ADDENDUM NUMBER 02

DATE: May 12, 2026

PROJECT: **CHEAHA STATE PARK FIRE STATION**

PROJECT NUMBER: **ASPD PROJECT #: 2026-005-16FS**

PROJECT NO:	R08526001
DATE:	04/17/2026
SHEET NO:	AS SHOWN
DRAWING TITLE:	ROOF PLANS

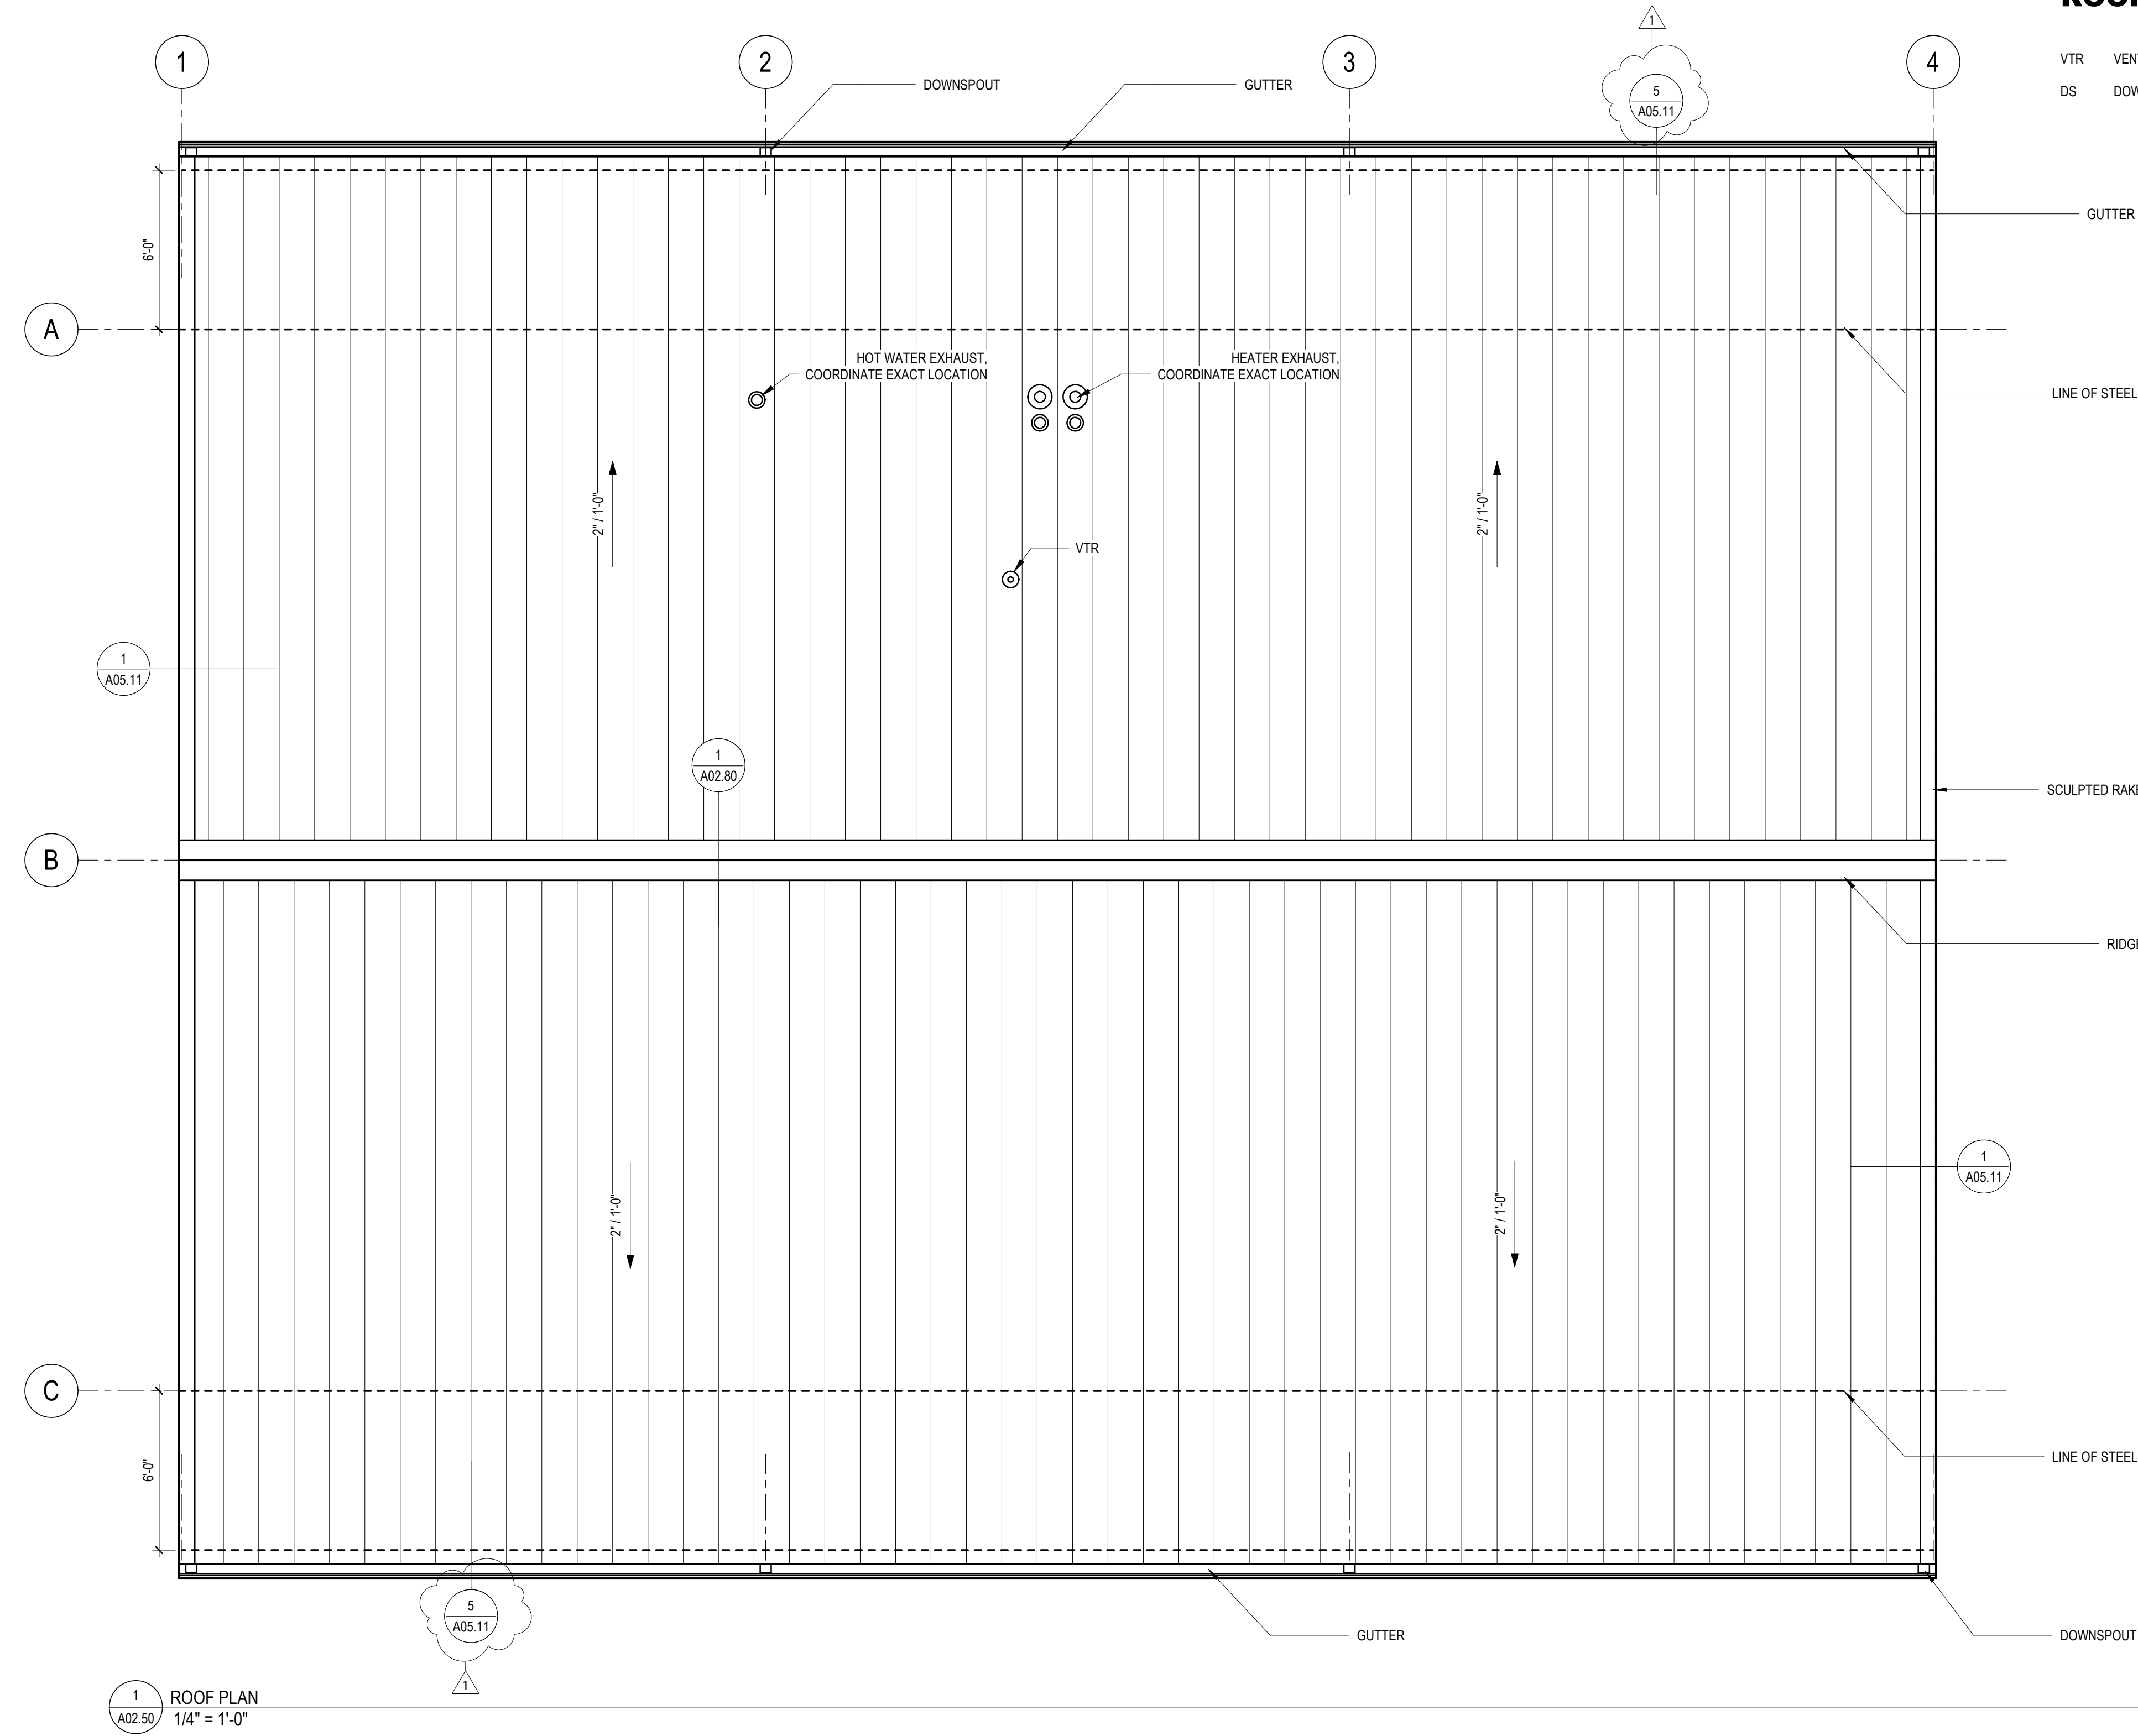
4. **Sheet A02-50 – ROOF PLANS**
 - a. Replace with the attached revised drawing.
 - b. Revision cloud reflects detail numbering change.
5. **Sheet A04-01 – EXTERIOR ELEVATIONS**

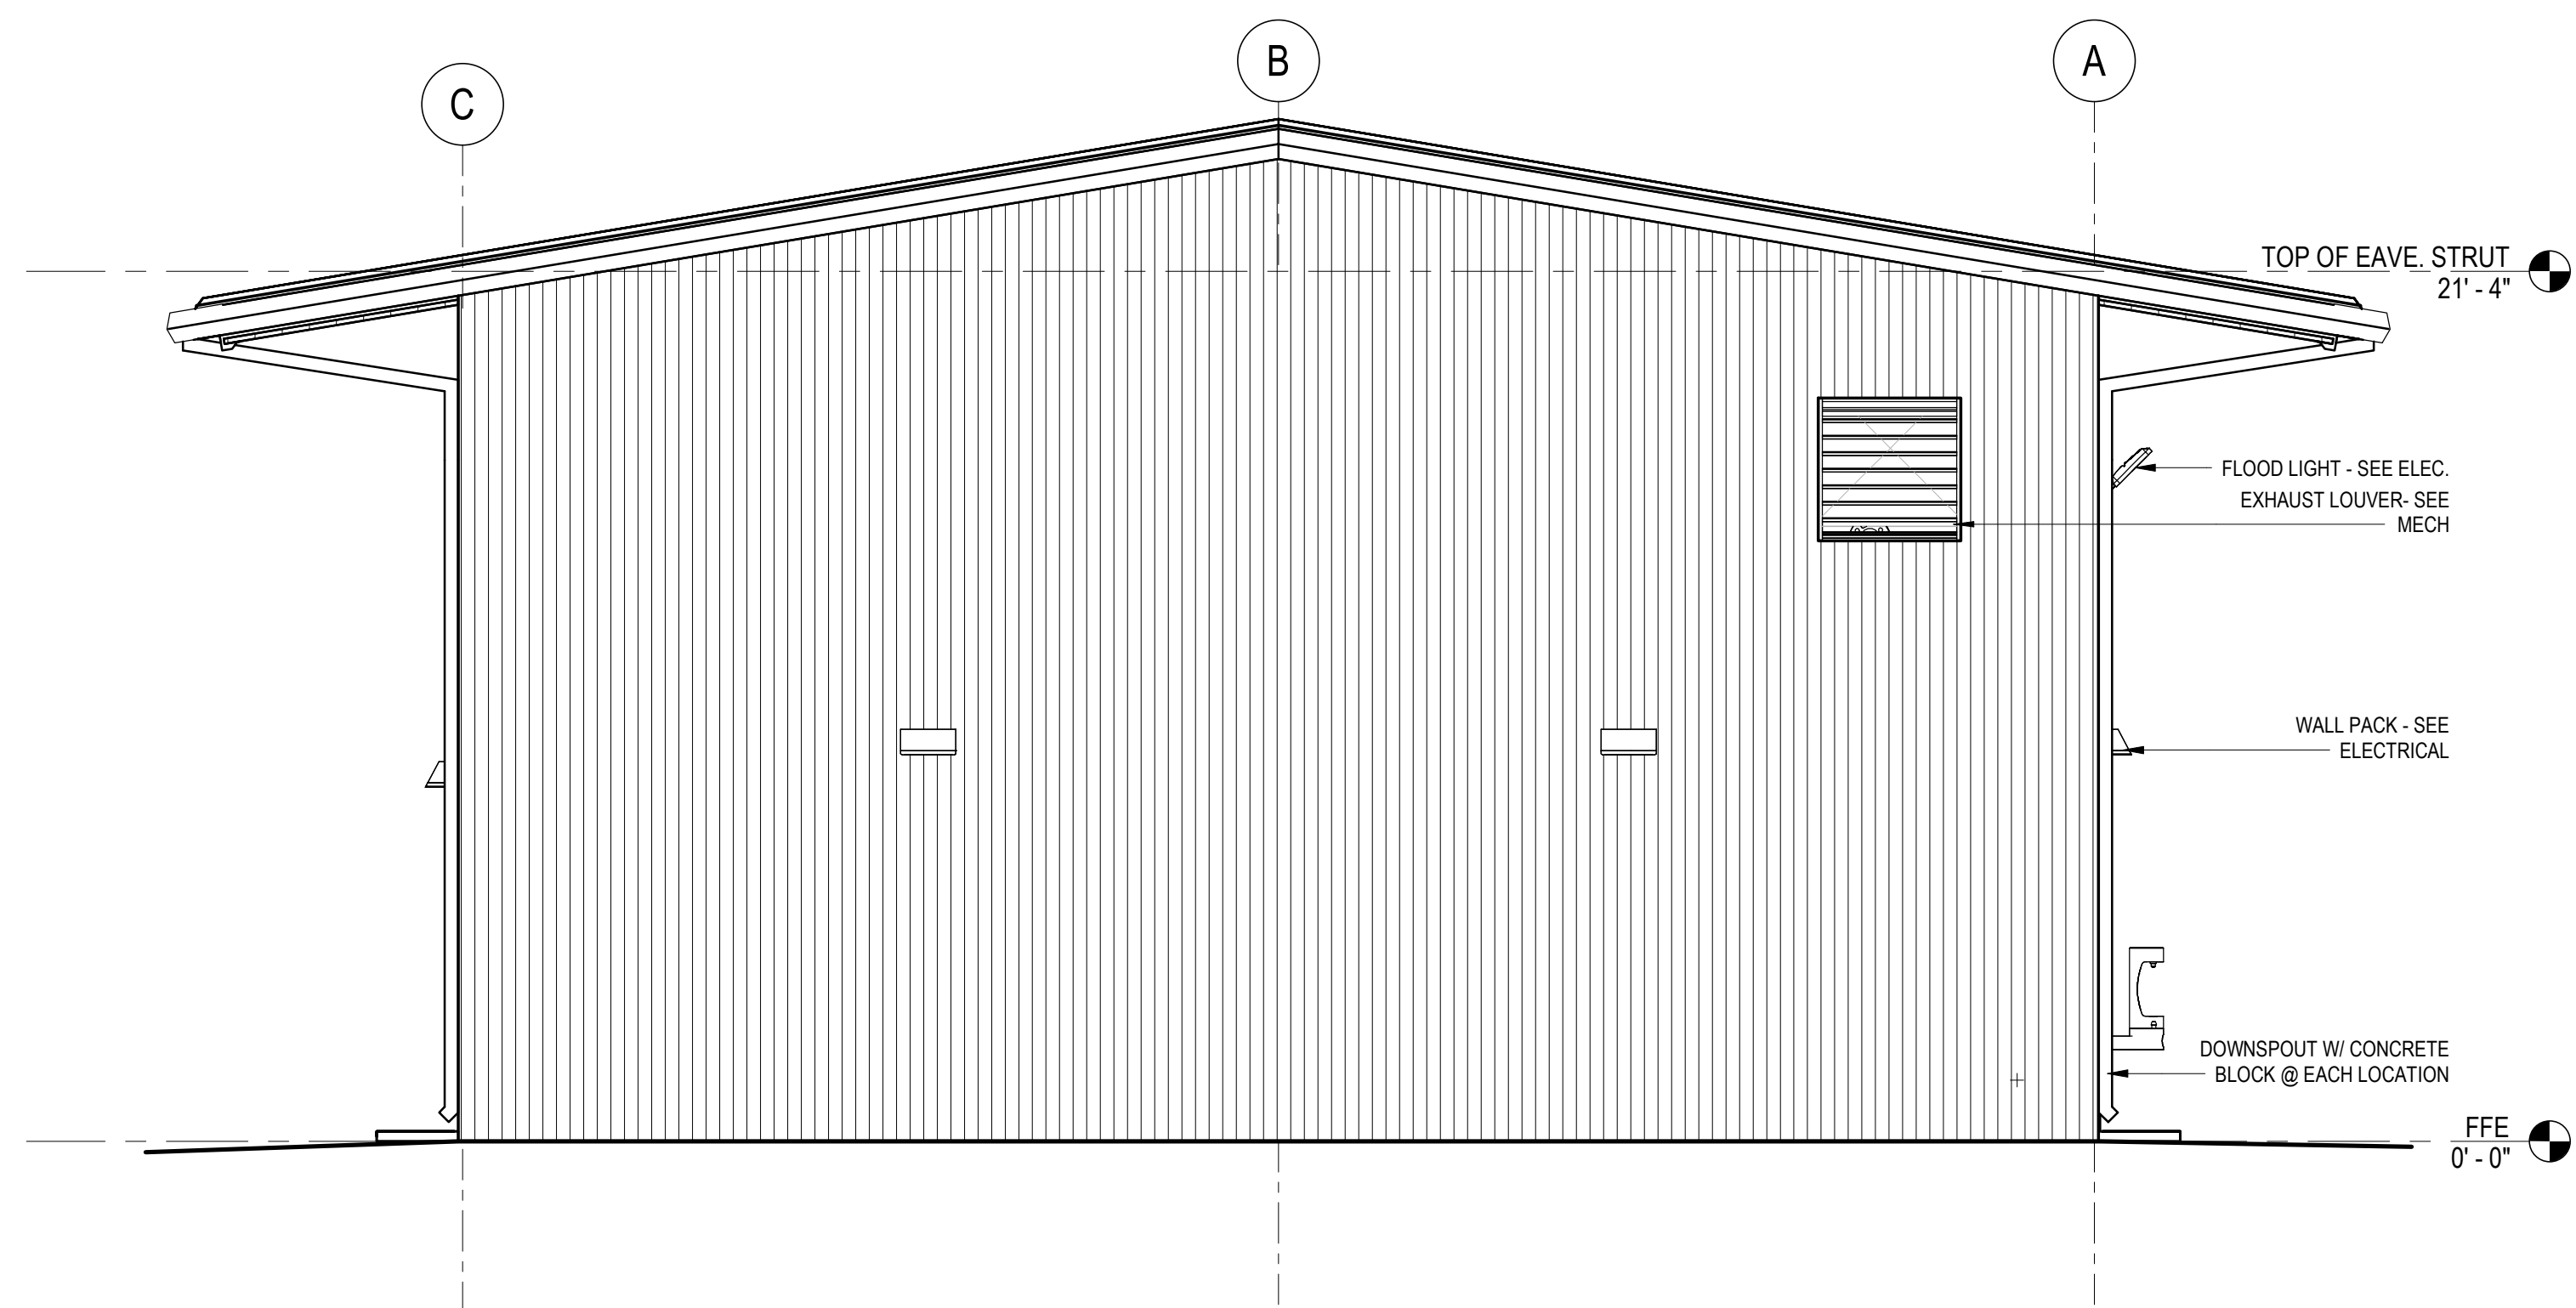
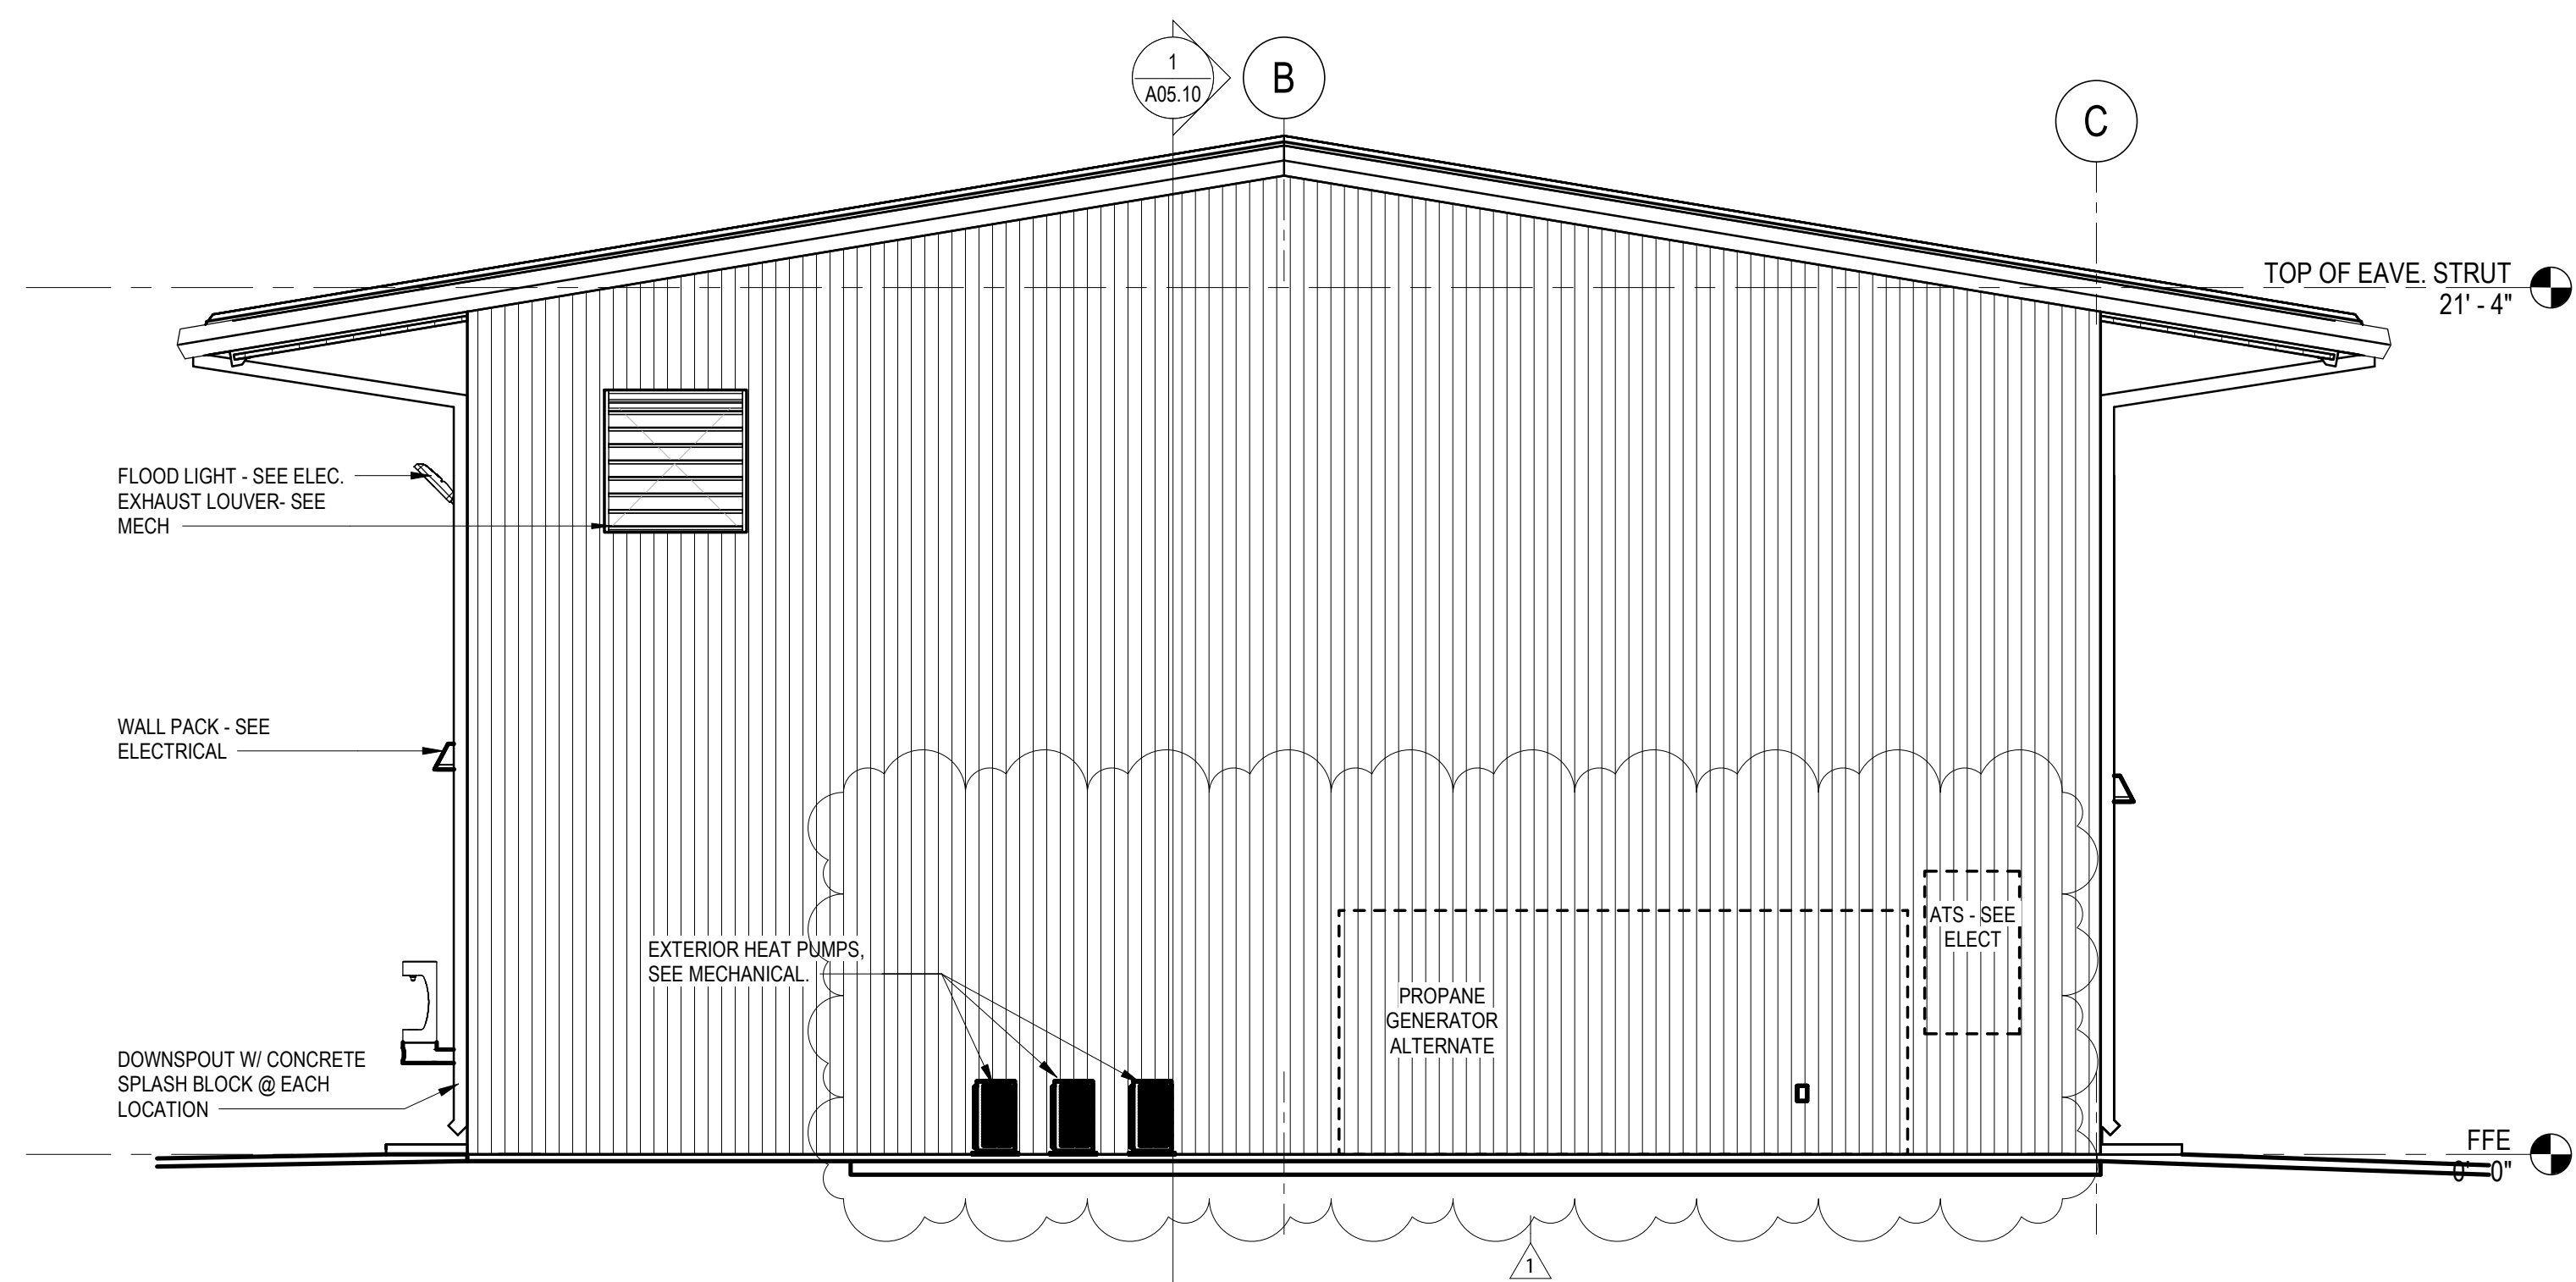
- a. Replace with the attached revised drawing.
 - b. Revision cloud reflects layout of mechanical pad.
6. **Sheet A05-10 – EXTERIOR WALL SECTIONS**
 - a. Replace with the attached revised drawing.
